Stair flip study · the main stair turned round: start and arrival at the NORTH end, next to the lift · Taif / Palm House V8.0 (work) · STUDY ONLY

ADOPTED 2 Nov 2026 (owner): option B, the freed landing as F-b, the balustrade, the store door onto the riwaq, the half-landing window, the entrance side light, the entry cupboard removed; applied to the design files. Owner's idea, 1 Nov 2026 · the same well (2.75 × 5.7 on axes, 2.525 × 5.50 clear), the same 22 risers × 0.164 / goings 0.28, flights 1.21 clear · nothing in the design files changes until the owner decides · all sizes assumed

1 · The two options on the ground floor

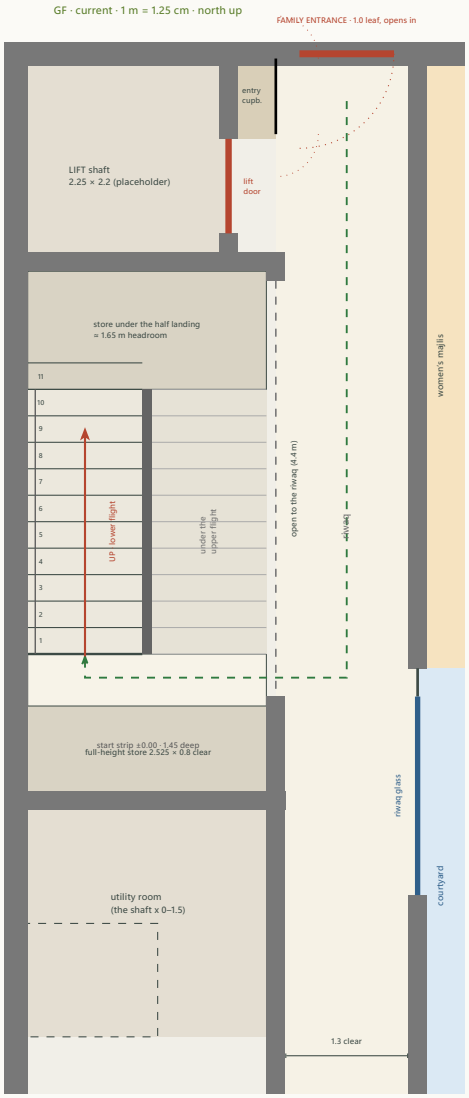
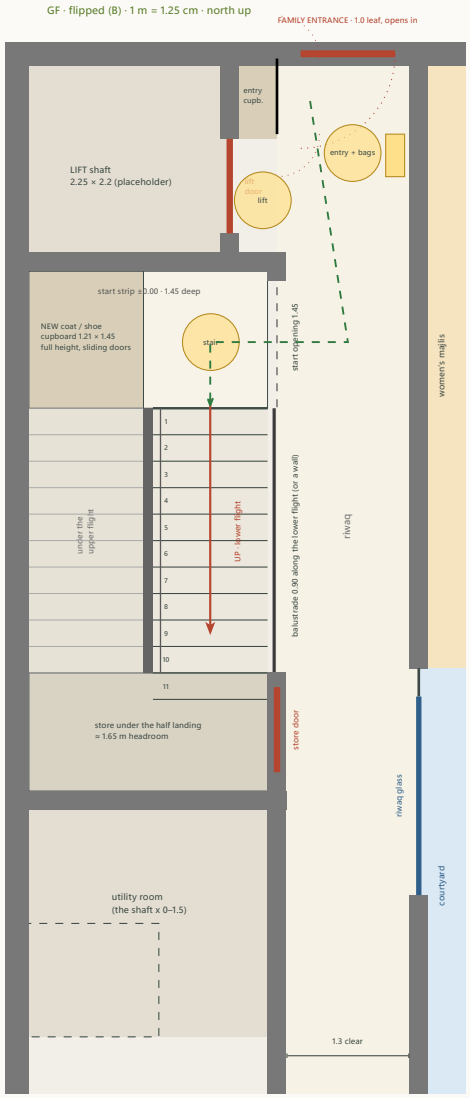
- **Current:** the lower flight on the **west** half starts at the **south** end (first riser y 6.35); the person comes along the riwaq, enters the well through its open east side (4.4 m open) and turns west onto the flight; in front of the first riser only **0.55 m** before the full-height store's wall (the start is really made from the side, under the upper flight's high end). Half landing at the north end (+1.80, a 1.65 m store below it, opening east onto the riwaq); the full-height store 2.525 × 0.8 clear at the south end.

- **Flipped (B, recommended of the two flips):** the lower flight on the **east** half starts at the **north** end (first riser y 3.75), **straight off the lobby**: a 1.45 m opening in the x 2.75 line between the lift notch and the flight, a start strip 1.45 m deep in front of the first riser. The lower flight rises along the riwaq side (a 0.90 balustrade on the riwaq, or a wall: the owner's choice); the half landing at the south end with its 1.65 m store (door onto the riwaq at y 6.7–7.6, in front of the courtyard glass; or into the utility room). The **west half of the start strip** (1.21 × 1.45, full height) becomes a **coat / shoe cupboard** beside the family entrance (sliding doors onto the strip).

- **Flipped (A):** the mirror image only (the lower flight stays west): the person crosses the whole strip to the far half before climbing; no cupboard. Not recommended; everything else below holds for both.

2 · Congestion test at the flipped start (drawn)

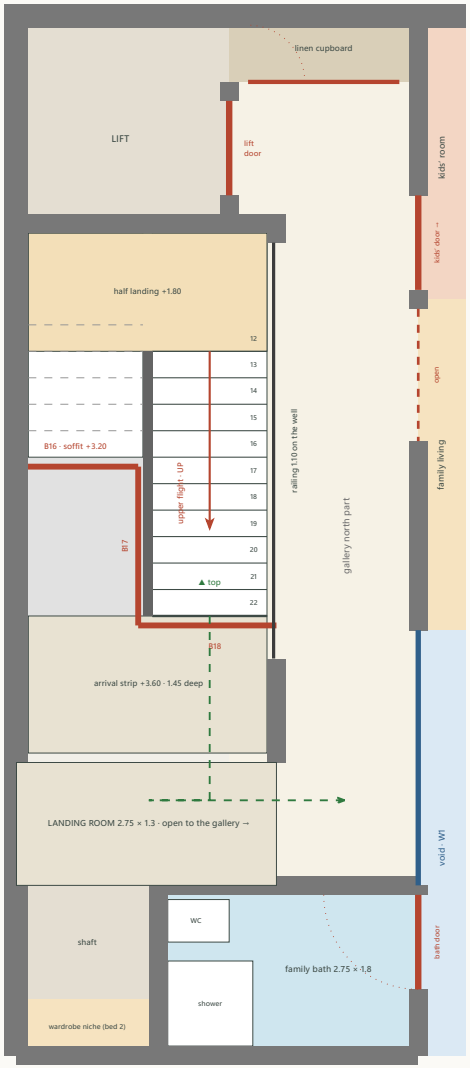
Three people at once: **one waiting for the lift** in the 0.50 m notch in front of its sliding door, **one coming in with bags** inside the family entrance's 1.0 m swing, **one starting up the stair** on the start strip, with the **entry cupboard's two 0.45 leaves open** into the lobby. Clear widths, not axes: the lobby **1.3 m** between the lift / cupboard wall face and the women's majlis wall face (the notch adds 0.5 m at y 0.9–2.2); the start opening **1.45 m**; the first riser **1.21 m** wide; the entrance **0.9 m** clear. The three stand in three separate zones along the lobby (y 0–1.0 the door swing, y 0.9–2.2 the lift notch, y 2.3–3.75 the start strip); the stair starter passes 0.3 m south of the lift waiter and never crosses the entrance swing: **OK**. Two people can pass in the 1.30 m lobby (0.60 + 0.60 + 0.10) but a person with two bags blocks it for a moment, as today. **Furniture up the stair:** the 90° turn from the 1.30 lobby through the 1.45 opening onto the 1.21 flight is a tight but normal house stair turn; the current start (0.55 m strip, sideways) is worse.

FF · current · 1 m = 1.25 cm · white = opening · grey = slab

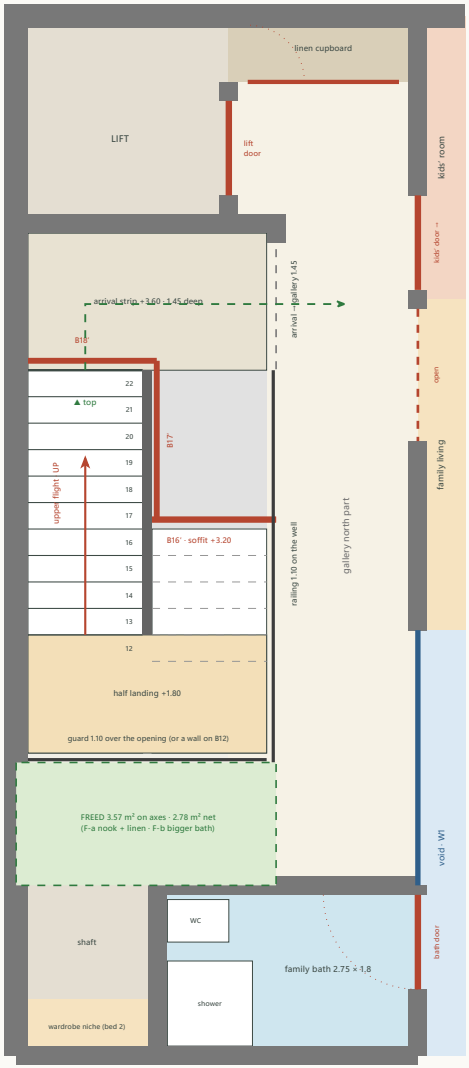
- **Current:** the upper flight (east half) lands at +3.60 on the arrival strip (y 6.35–7.8), then the **landing room** (2.75 × 1.3, y 7.9–9.2) and east into the gallery; the bedrooms and the family bath are at hand, the kids' room, the living and the lift are 6–9 m north along the gallery.

- **Flipped (B):** the upper flight (west half) lands on the arrival strip at the **north** end (y 2.3–3.75); the strip opens east onto the gallery's north part (1.45 m), **0.10 m south of the lift notch**: the lift's first-floor door, the linen cupboard (its leaves swing south, 0.6 m), the kids' room door (opens into the room) and the family living's opening are all within 1–3 m. The gallery's north part (1.30 clear) carries the arrival traffic as it carries the lift's today; the linen leaves and the lift door are 1.0 m north of the arrival: no clash. The railing on the well runs from the arrival (y 3.75) to the south wall; the landing room is **freed** (§ 5).

FF · flipped (B) · 1 m = 1.25 cm · white = opening · grey = slab

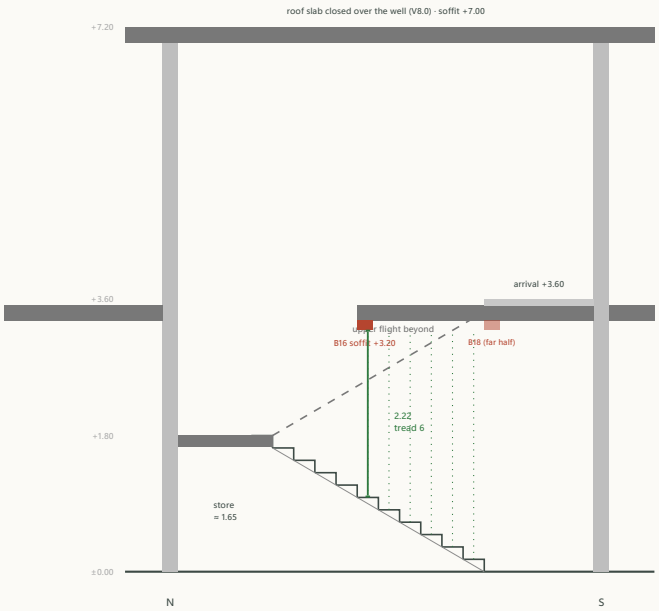
- **Current (studies/structure.typ):** an L-shaped opening ≈ 8.2 m²: the west half open from the north wall to B16 (y 4.85), the east half open to B18 (y 6.45); B16 (0.20 × 0.40, soffit +3.20) from the west wall to B17; B17 (x 1.29, on the lower flight's side of the split) from B16 to B18; B18 (y 6.45) from B17 to the riwaq-line beam B10 (x 2.75).

- **Flipped (B):** the **same opening turned round** (≈ 8.2 m²): the east half open from B16′ (y 5.33) to the south wall, the west half from B18′ (y 3.65) to the south wall. **B16′** (y 5.33) from the riwaq-line beam B10 to B17′; **B17′** (x 1.49, on the east, lower flight's side of the split: never over the upper flight) from B16′ to B18′; **B18′** (y 3.65, the arrival edge) from the west wall to B17′. The same zigzag, mirrored: one beam-on-beam junction at each end of B17′, the torsion the engineer's; B18′ now bears on the west wall (as B16 does today) and B16′ on B10 (as B18 does today). **Neither better nor worse** for the structure: the spans (1.3–1.6 m) and the bearings are the same kind. **Not verified.**

- **Slab edges:** the arrival strip (1.45 × 2.525) spans between the north wall beam B11 (y 2.2) and B18′; over the lower flight's first six treads the slab spans from B18′ to B16′ (1.6 m) between B10 and B17′. The guard round the opening: the railing on x 2.75 from the arrival south to y 7.9, the well's south wall line y 7.9 (a 1.10 guard or a wall on B12), the upper flight's balustrade on the split.

Headroom · a section along the lower flight for each option · the slab 0.2 thick (soffit +3.32), the trimmers 0.20 × 0.4 (soffit +3.20), the finish 0.08 · over the full walking width of every tread

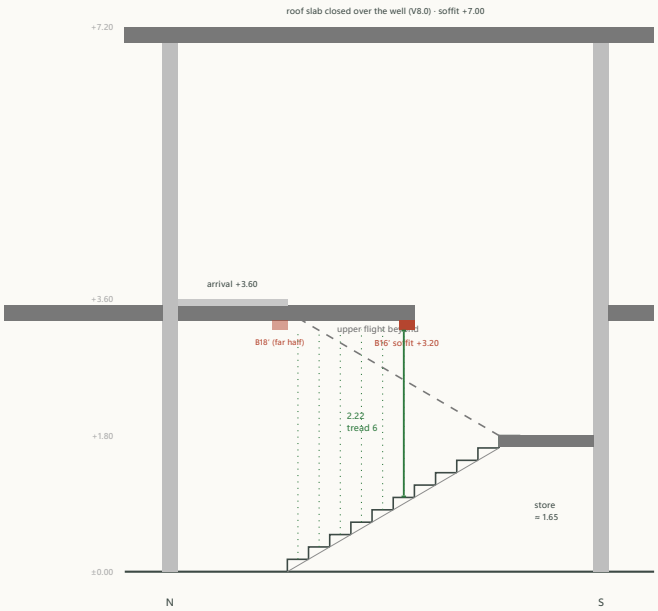
The upper flight, the half landing and the arrival are under the open well (the roof slab's soffit +7.00): ≥ 3.4 m. Minimum of this option: **2.22 m** at tread 6 under the trimmer, across the whole 1.21 m width (the trimmer spans the half); B17 over the inner 0.10 strip of treads 1–5: ≥ 2.38 m.

The upper flight, the half landing and the arrival are under the open well (the roof slab's soffit +7.00): ≥ 3.4 m. Minimum of this option: **2.22 m** at tread 6 under the trimmer, across the whole 1.21 m width (the trimmer spans the half); B17′ over the inner 0.10 strip of treads 1–5: ≥ 2.38 m.

Verdict on the headroom: identical in both options (**2.22 m** at tread 6 under the trimmer, 2.83 m at tread 3 under the slab; ≥ 2.10 required, the 2.20 aim just met) because the flip mirrors the geometry: the trimmers sit in the same places relative to the treads. **The flip neither improves nor worsens the trimmers.** What would improve both: trimmers 0.20 × **0.30** (soffit +3.30 → **2.32 m** at tread 6) if the engineer accepts a 0.30 depth for the 1.3–1.6 m spans, or the slab edge moved one tread (the opening 0.28 m longer, ≈ 0.35 m² more void, tread 6 under open sky → the minimum moves to tread 5: 2.38 m). Both options can take either. The walls' handrails run the full flights (0.08 off the walls); the central handrail on the 0.10 split.
